Subject: **MHI's Response to US-APWR DCD RAIs No. 939-6334 Revision 3 (SRP 03.07.01) and No. 940-6532 SRP (03.07.01)**

Response to Request for Additional Information No. 939-6334
Revision 3

US-APWR Design Certification

RAI NO.:	**NO. 939-6334, REVISION 3**
SRP SECTION:	**03.07.01 – Seismic Design Parameters**
APPLICATION SECTION:	**3.7.1**
DATE OF RAI ISSUE:	**06/12/12**

Figure 1, Design Acceleration Time History (Northridge) – X Component (H1, North-South) Developed using SRP 3.7.1, Option 1, Approach 1

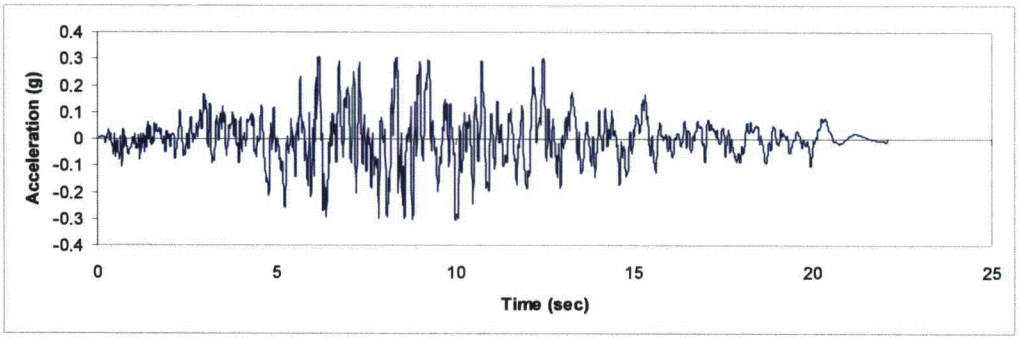
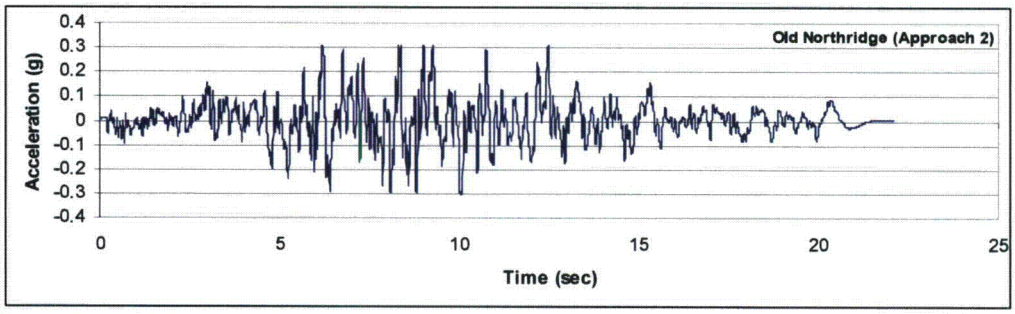
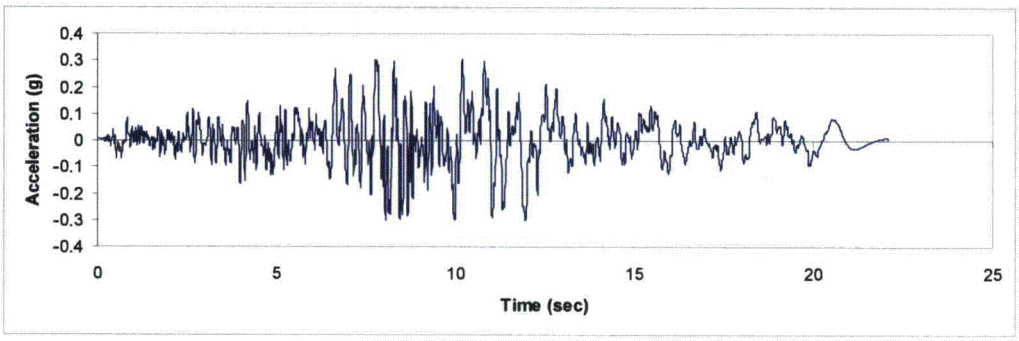
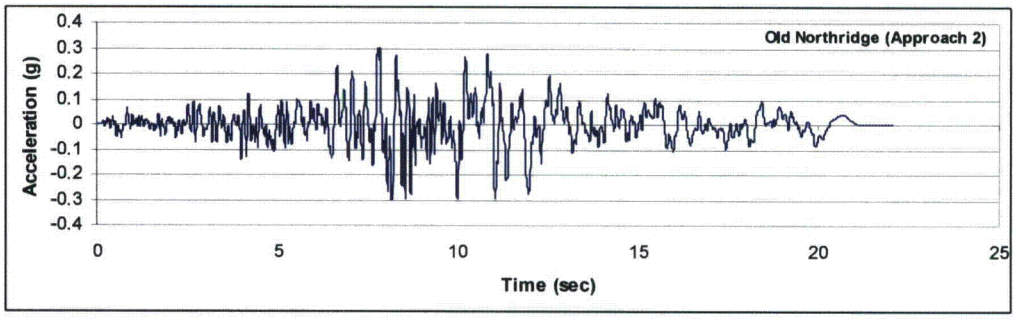
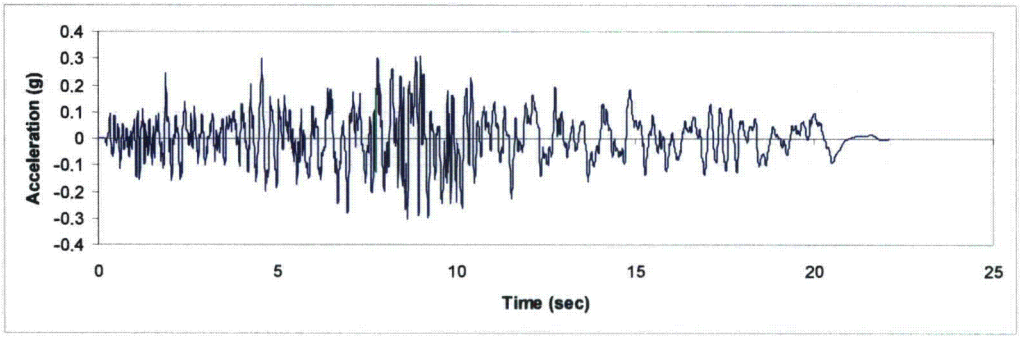
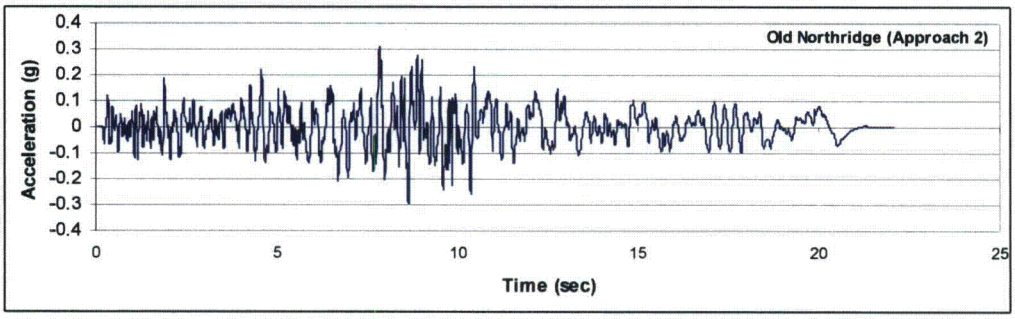
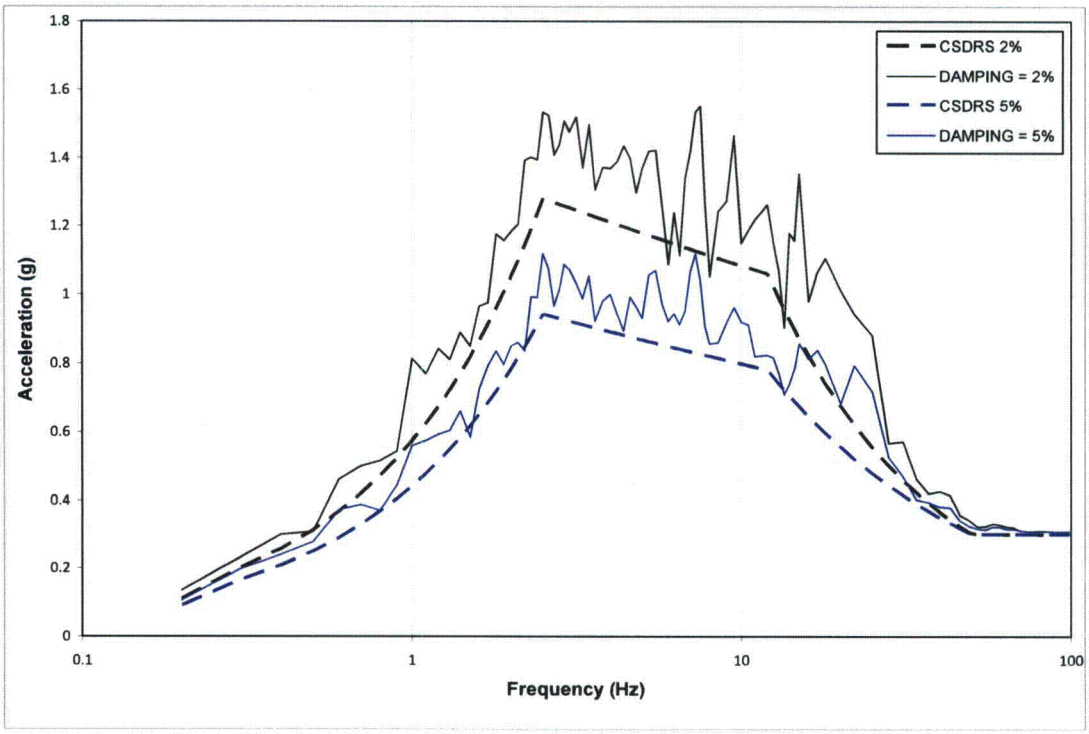
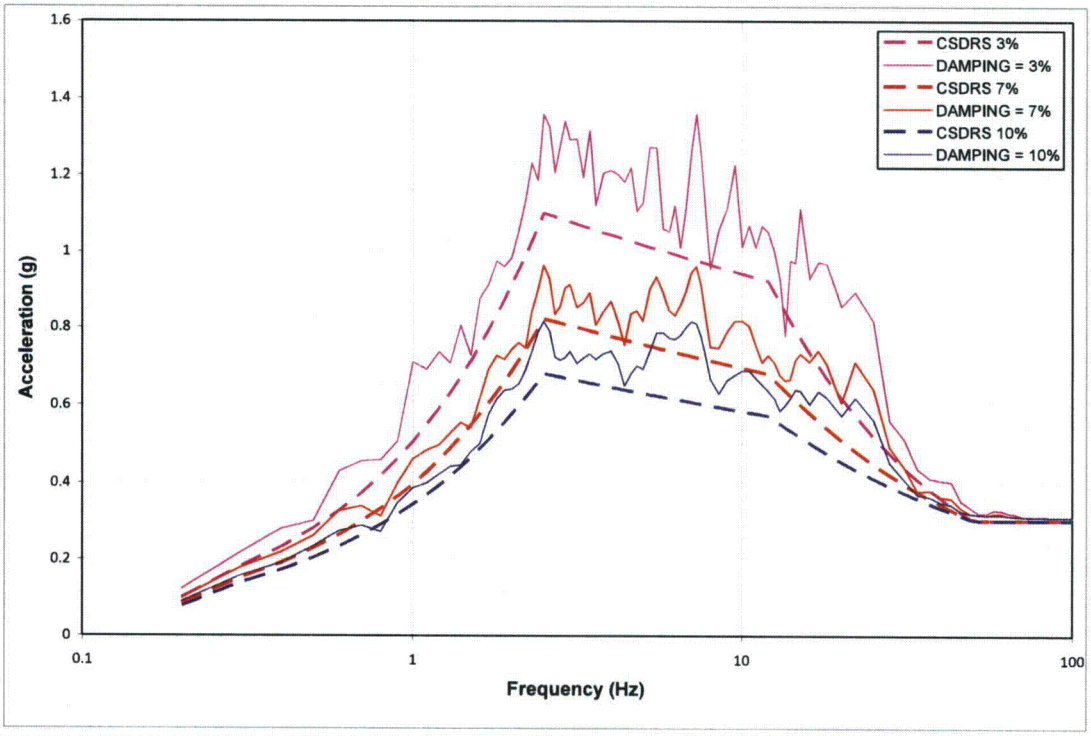
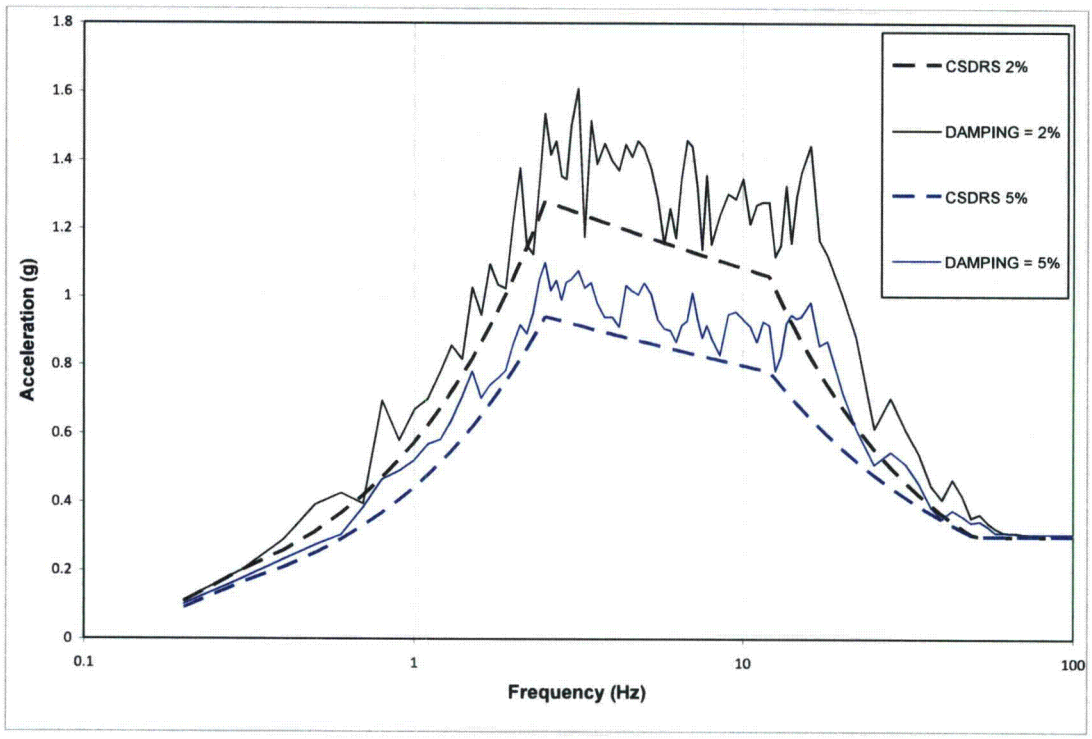
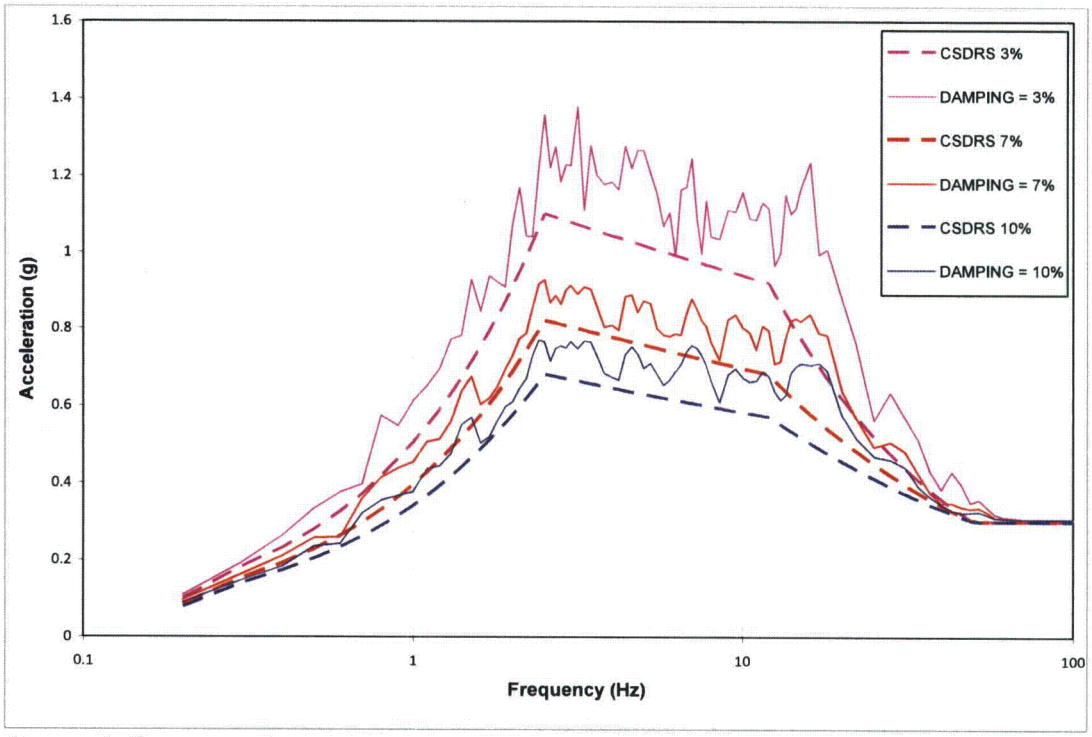
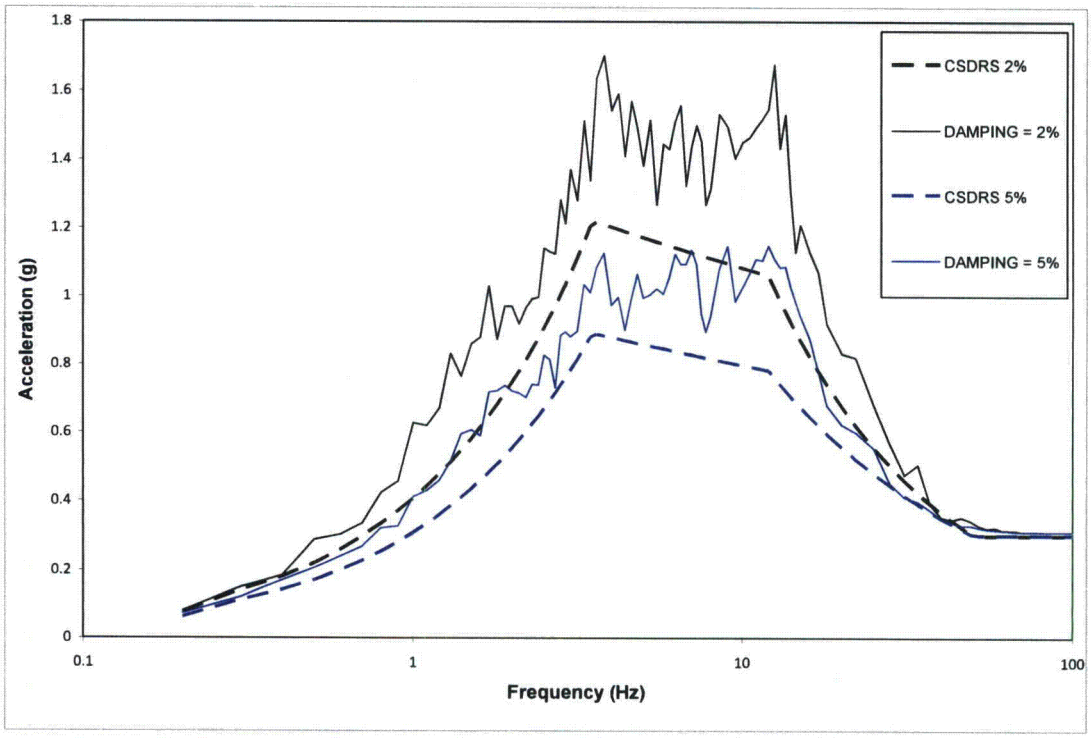
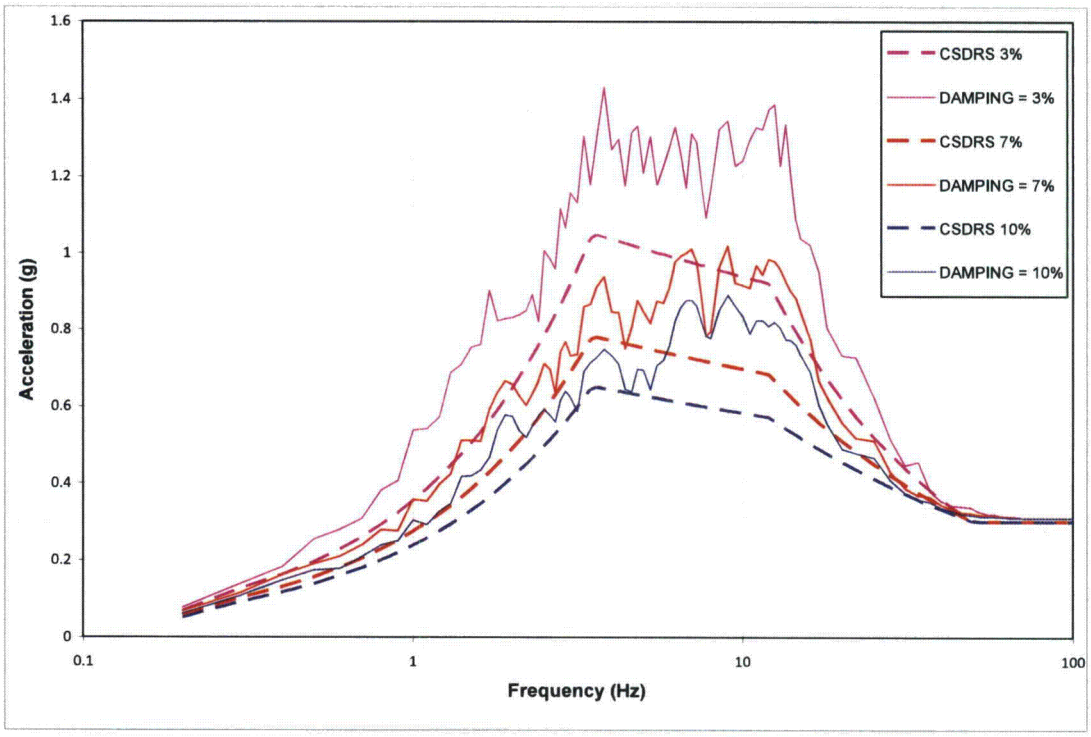
The applicant has specified that SRP 3.7.1, Option 1, Approach 2, criteria are satisfied. However, the staff has determined that Option 1, Approach 2, is not specifically applicable to site-independent CSDRS based on the RG 1.60 spectra. The acceptance criteria in Option 1, Approach 2, are not appropriate for site-independent CSDRS; rather it is applicable for developing synthetic time histories to match a site-specific uniform hazard response spectrum (UHRS).

(1) In performing the spectral matching, demonstrate that for all three directions of the CSDRS, the Option 1, Approach 1, criteria are met for 2%, 3%, 5%, 7%, and 10% damping, or justify an alternate damping range based on the values used in the design basis seismic response analysis of SSCs.

MHI has revised the time history methodology used to develop the time history for structural design and in-structure response spectra (ISRS) development to satisfy the SRP 3.7.1 Option 1, Approach 1 criteria. (The terminology used here for time history refers to all thee components, i.e., North South, East West and vertical.) The design basis time history in Technical Report MUAP-10006, Rev. 3 is being developed to satisfy the spectral matching criteria and power spectral density (PSD) matching criteria of the SRP 3.7.1, Option 1, Approach 1. The details of how the time histories were developed using SRP 3.7.1 Option 1, Approach 1 and how the SRP guidance criteria are satisfied are discussed below:

The Modified Northridge time histories were redeveloped according to the provisions of SRP 3.7.1 Option 1, Approach 1 (Reference 1), at 2%, 3%, 5%, 7%, and 10% damping. As requested in our June 21, 2012 meeting, Figure 1 through 6 compare the current modified Northridge time histories with the previous modified Northridge time histories, which were developed using Option 1, Approach 2 criteria. Figure 7 through 12 depict the response spectra of the modified Northridge time histories developed in accordance with SRP 3.7.1 Option 1, Approach 1.

Figure 13, US-APWR Horizontal and Vertical Target PSDs vs. SRP Target PSD

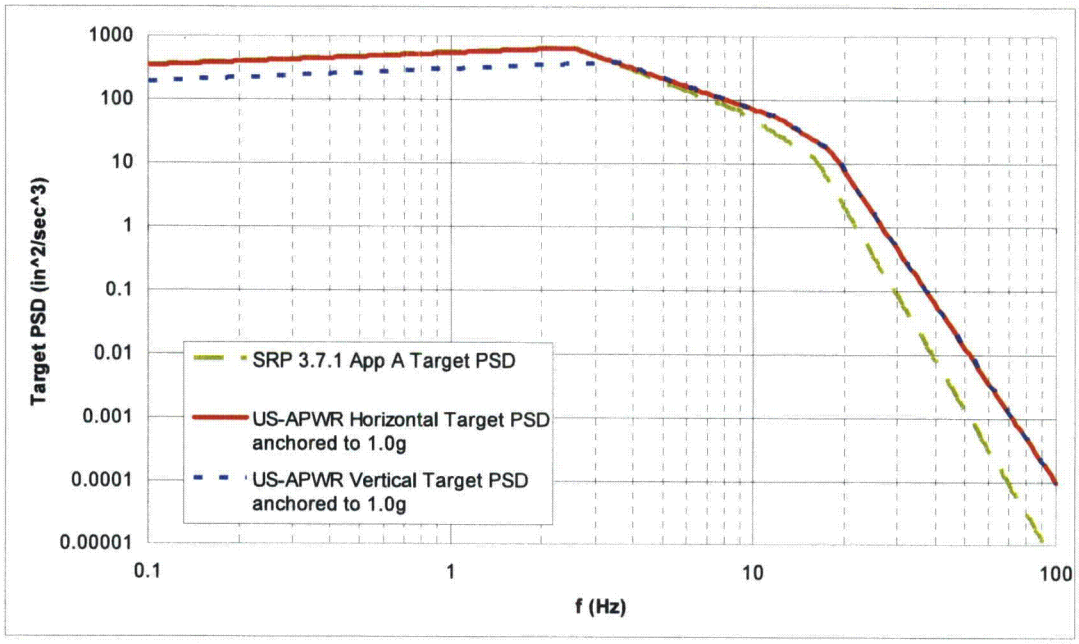
(b) provide the details of the method employed to develop the target PSDs; and

As shown in Equations (1) and (2), and Figure 13, the slope of the second leg is modified to 1.6 from 1.8, which makes this leg of the PSD "flatter" than the PSD for RG 1.60 spectra. Further, the slope of the fourth leg is modified to 7 from 8, which makes this leg flatter. The control point at 9 Hz is extended to 12 Hz, and the control point at 16 Hz is extended to 18 Hz from the SRP 3.7.1 target PSD. All of these changes increase the power requirement at frequencies above 2.5 Hz.
